CALIFORNIA COASTAL COMMISSION  
89 South California Street, Suite 200  
Ventura, CA 93001  
(805) 641-0142

**STAFF REPORT: REGULAR CALENDAR**

**APPLICATION NO.:** 4-93-206

**PROJECT DESCRIPTION:** Subdivision of 80 acres developed with one single family residence into 6 lots, ranging in size from 10-acres to 15-acres, with 67,300 cu. yds. of grading (34,500 cu. yds. cut and 32,800 cu. yds. fill) to construct access driveway and 5 building pads, each over one-half acre in size.

**EXHIBIT 2**  
 4-93-206  
 GRADING  
 PLANS- Lots  
 1 and 2

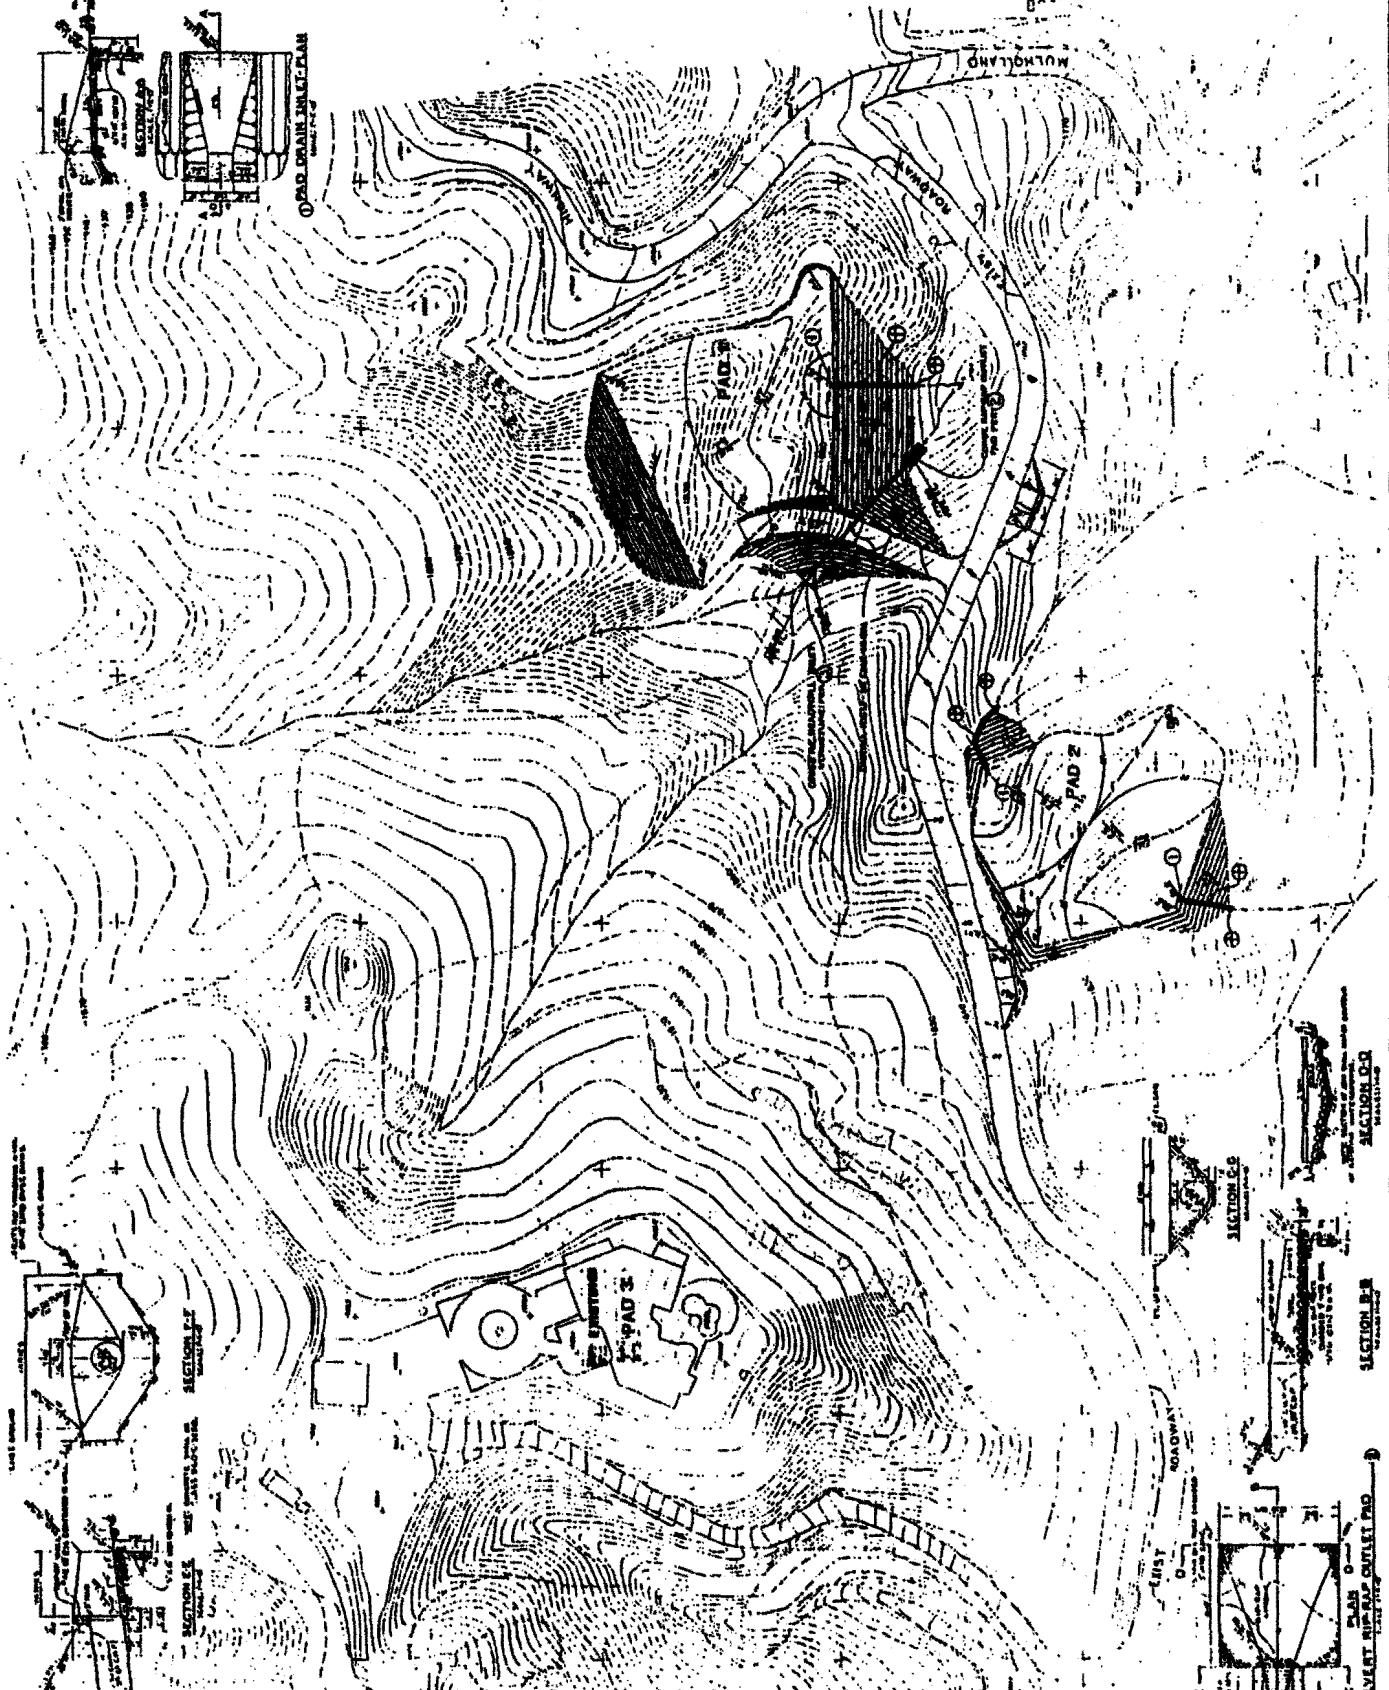
For instance, the pad for the proposed Lot 1 would require 18,000 cu. yds. of grading and would include the construction of a cut slope behind the pad and 50 feet in length. Additionally, a fill slope would be constructed downslope of the pad which would be and 70 feet in length. This pad would be very visible from Mulholland Highway directly adjacent to the site and from several public riding and hiking trails in the area. This large amount of grading results in a significant alteration of the natural landform and creates a "manufactured" unnatural landscape. This large cut and fill flat pad design clearly does not minimize grading or blend with the natural landform.

In this case, grading has not been minimized, as required by LUP policies P82, P90, P91, or P130. The proposed project includes very large, flat pad areas. Each proposed pad would be over one-half acre in size. As a point of comparison, the maximum pad size standard (Table 1 of the LUP) for properties within Significant Watershed areas is 10,000 sq. ft. In past permit actions, the Commission has found that a 10,000 sq. ft. pad is sufficiently large to allow for the construction of a single family residence and at least one ancillary structure like a guest house. The proposed project site is located just outside the Trancas Canyon Significant Watershed and would not be subject to this policy. However, it gives an idea of the size pad that the Commission has previously found would minimize impacts to sensitive areas.

In this case, the most obvious alternative would be for the applicant to reduce the size of the proposed building pads. With this modification, there would be a commensurate reduction in the amount of grading and in the overall height and length of the proposed manufactured slopes, consistent with LUP policies P82, P90, P91, P130, P134, and P135. Along with a reduction in size, the proposed pads could be redesigned to more closely conform to the natural terrain of the site. Large, rectangular pads are not consistent with the terrain of the project site. Contour grading techniques could be utilized so that the pads would blend more with the natural topography, consistent with LUP policy P134. Split level pad design could be implemented to reduce overall grading. Additionally, several of the proposed parcels could be designed for future residences that would be built to the existing slope as much as possible, with just enough grading to construct a driveway and fire department turnaround area, thereby significantly reducing landform alteration. These measures could be implemented to redesign the proposed project to minimize the alteration of natural land forms, consistent with Section 30251 of the Coastal Act. Houses of significant size could still be constructed on smaller pads, while minimizing impacts to visual resources.

**EXHIBIT 3**  
 4-93-206  
 GRADING  
 PLANS- Lots  
 4, 5, and 6

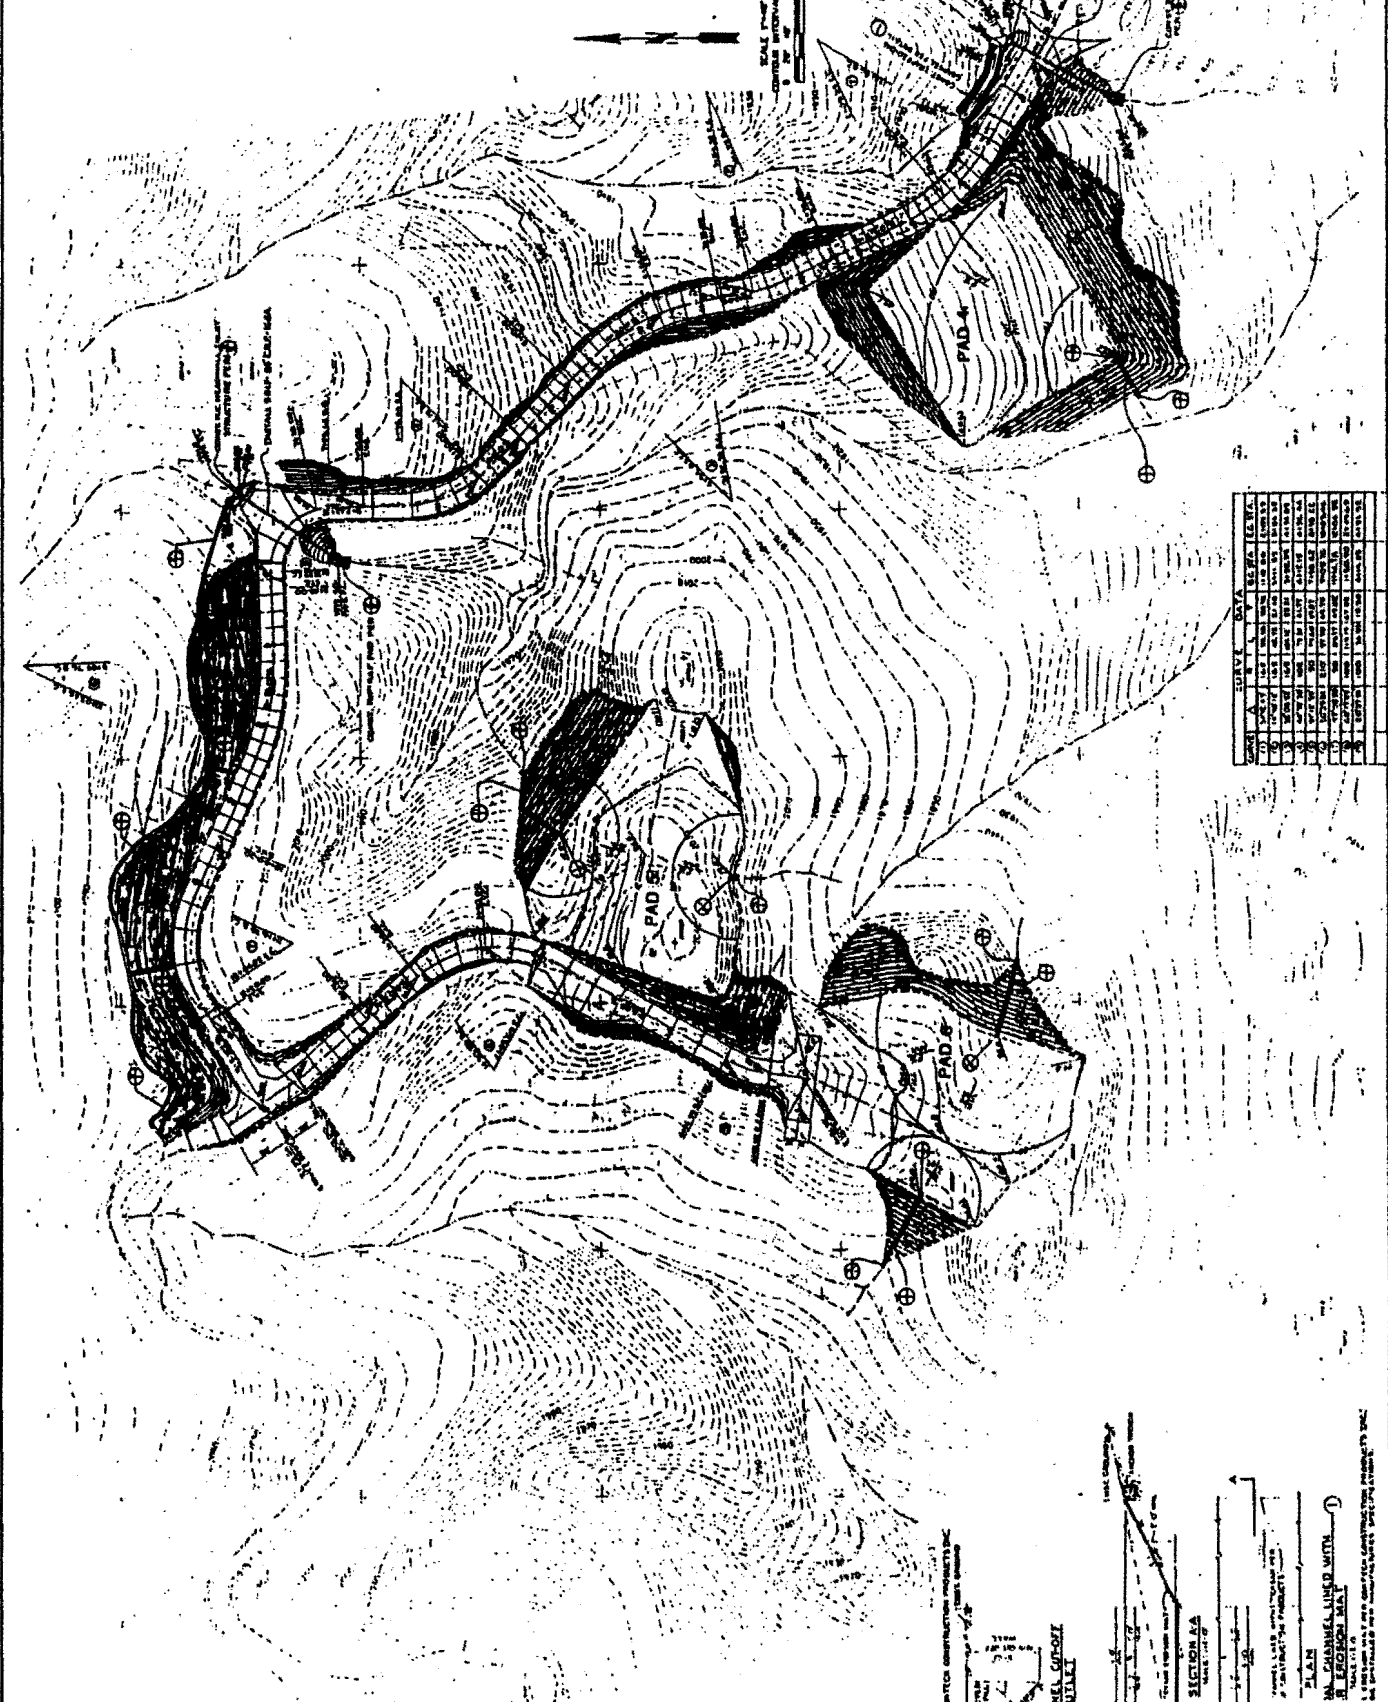
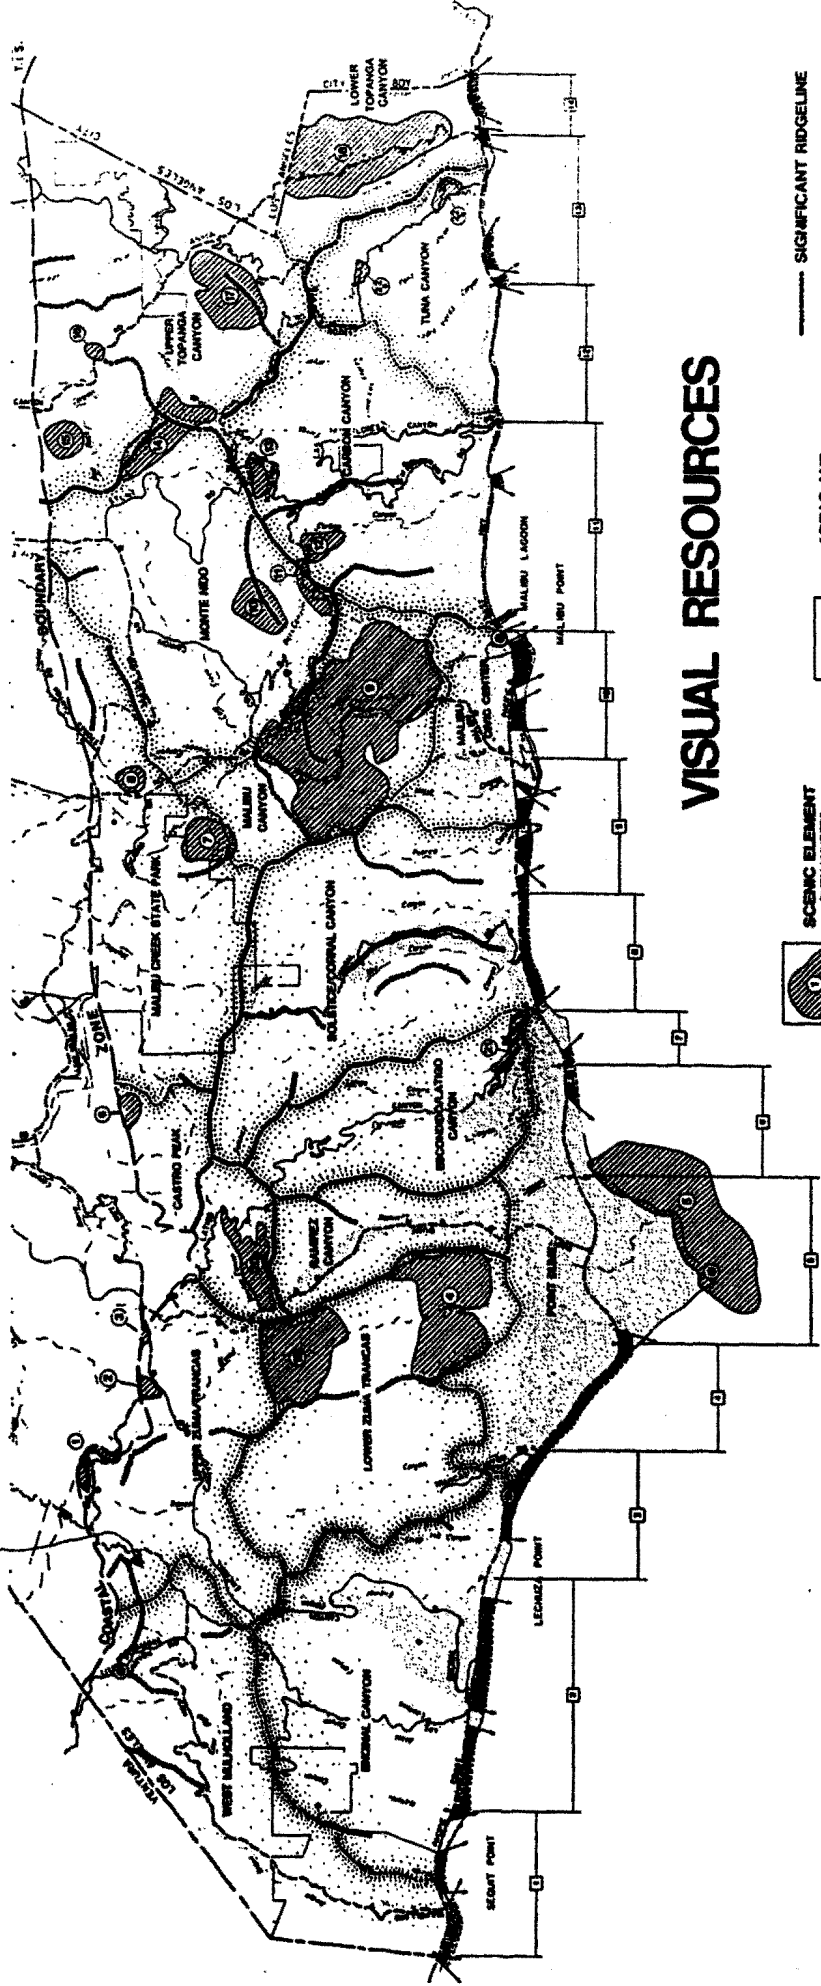
The proposed building pad for Lot 4 is also very large in size and involves 13,000 cu. yds. of grading. This pad would be 24,500 sq. ft. in size, would be square in shape and

would include slopes of 40 feet (cut) and 70 feet (fill) in length. Lots 5 and 6 would require a significant amount of grading to construct (23,300 cu. yds.). While the County of Los Angeles did require the applicant to retain two knoll features in order to screen the pads from Mulholland Highway, these two pads would still be visible from public trails and from Decker Canyon Road. Each pad would be 28,000 sq. ft. in size. Additionally, 7,500 cu.yds. of grading and cut slopes of 60 feet in length would be required to improve the access road to the western area of the site. As previously noted above, this large flat pad design does not blend with the natural landforms on site and clearly does not minimize grading and landform alteration as required by Section 30251 of the Coastal Act. Although the proposed pad for Lot 2 would be 28,000 sq. ft. in size, the pad is located on a flatter area of the site and would require less grading (5,500 cu. yds.) and smaller slopes to construct. Additionally, this pad is located on a lower area of the site and would be much less visible than the other proposed pads.

Another alternative would be to cluster development, consistent with LUP policy P137, near the more developed eastern portion of the site, eliminating the pad for the proposed Lots 5 and 6. This would reduce the significant amount of grading required for these pads, as well as that required for the extension of the road. Coupled with a reduction of grading on the pads for Lots 1 and 4, it appears an additional pad could be constructed on the downslope side of the existing road, near the proposed pad for Lot 2 in conformance with the landform alteration policies. This alternative would also minimize the total area of the site devoted to fuel modification.
